City of Portland, Maine - Building or Use Permit Application

Permit No: 2012-65529	Issue Date:	CBL: 013 K045001
--------------------------	-------------	---------------------

Proposed Project Description:
1st floor: build a closet, move 3 doors, change suspended ceilings to sheetrock (5/8"), and other work as shown

109 Sheridan St. 1st floor

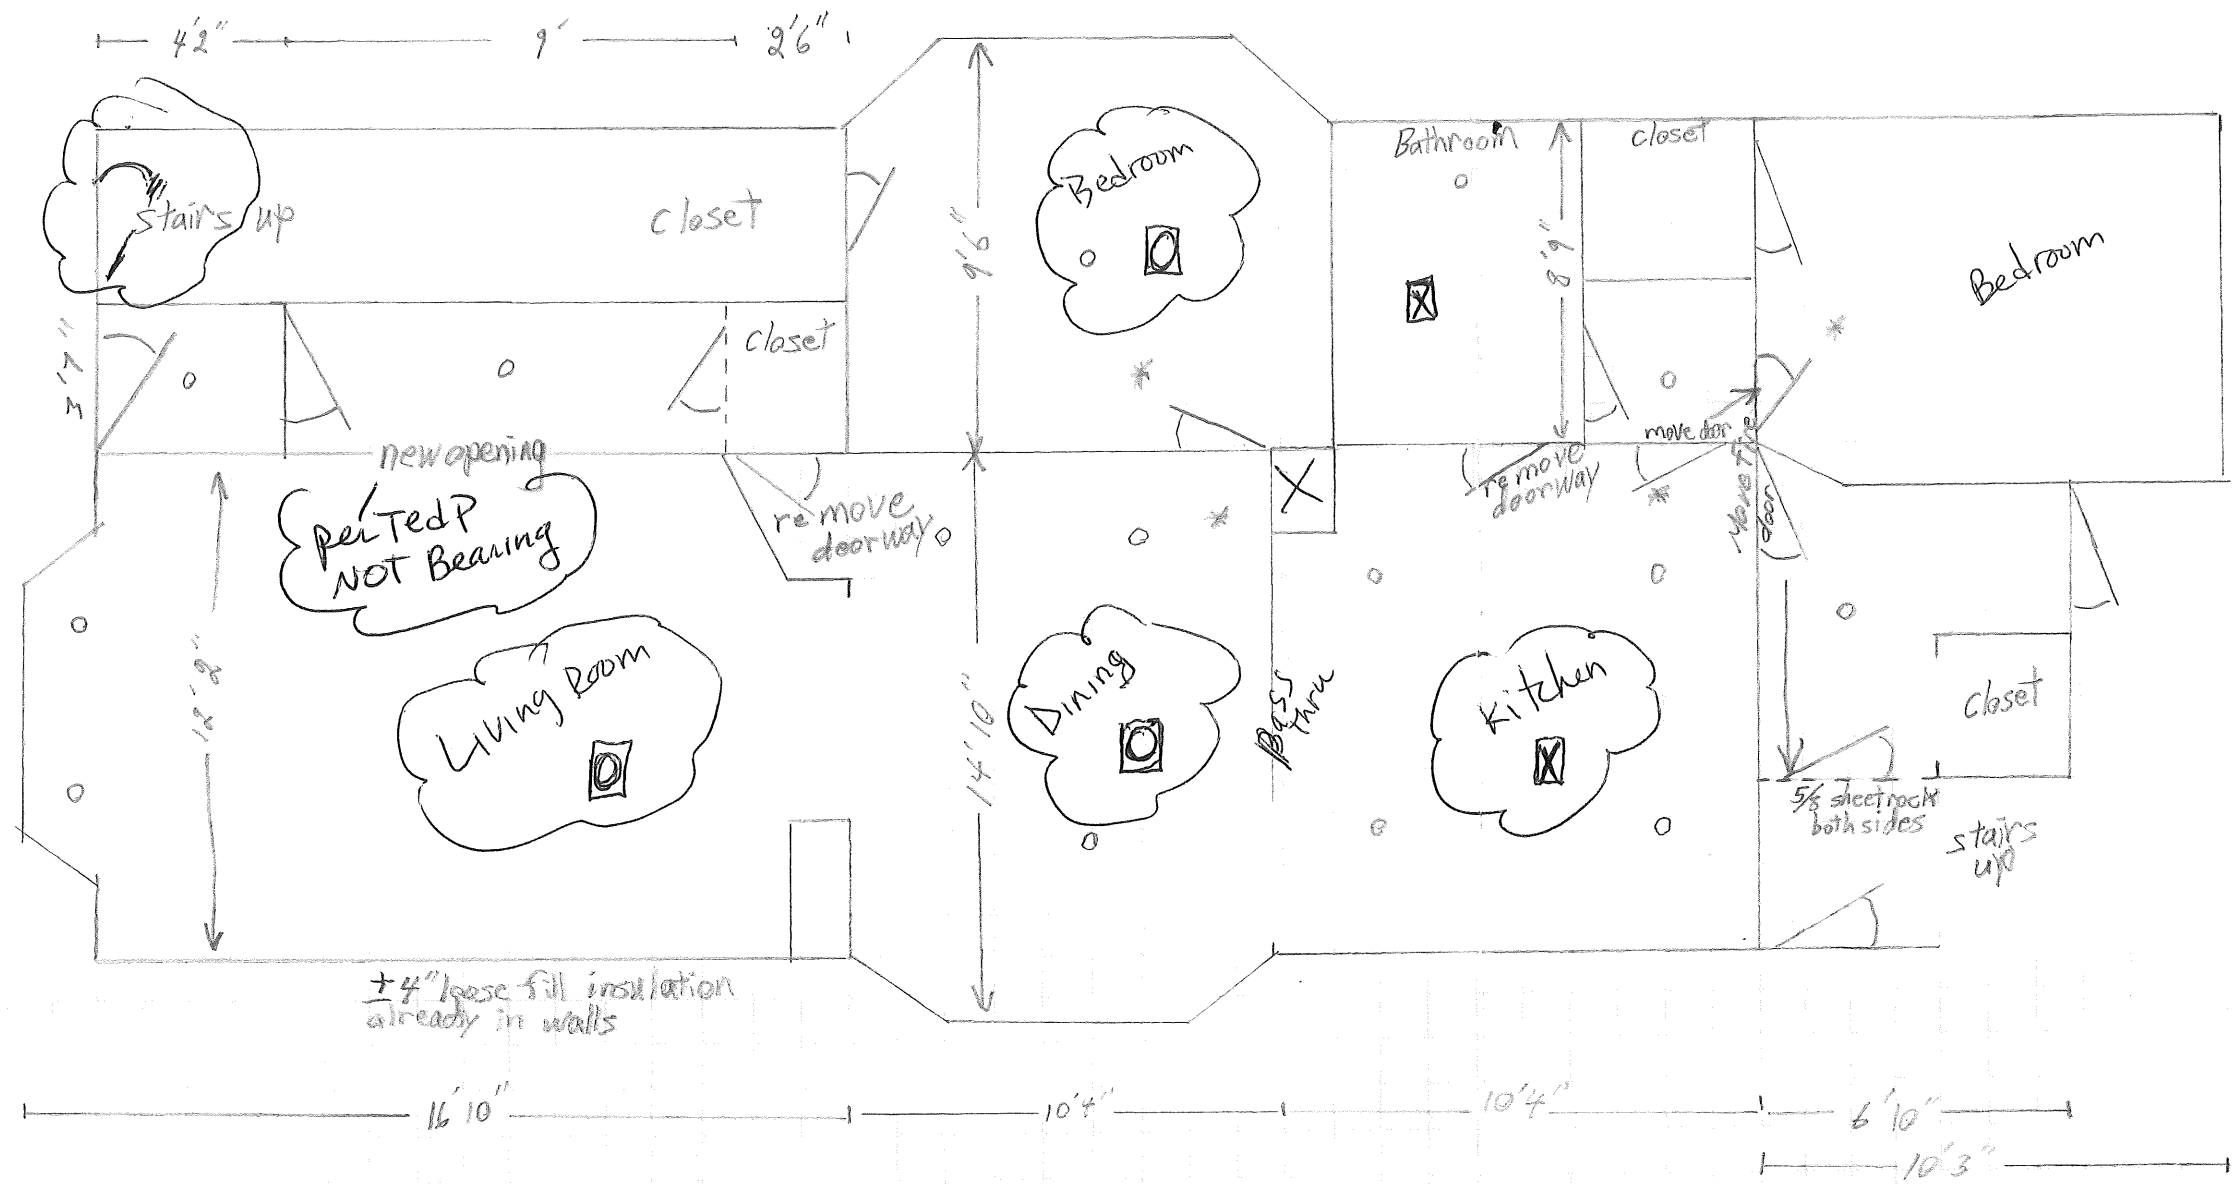
- ☒ - Drop ceiling Framing 2x4 w/ 3/4" insulation + type X 5/8
- ☒ - Type X 5/8 applied to existing strapping over 1'x1' fibertiles 12/18/12 per Ted P.
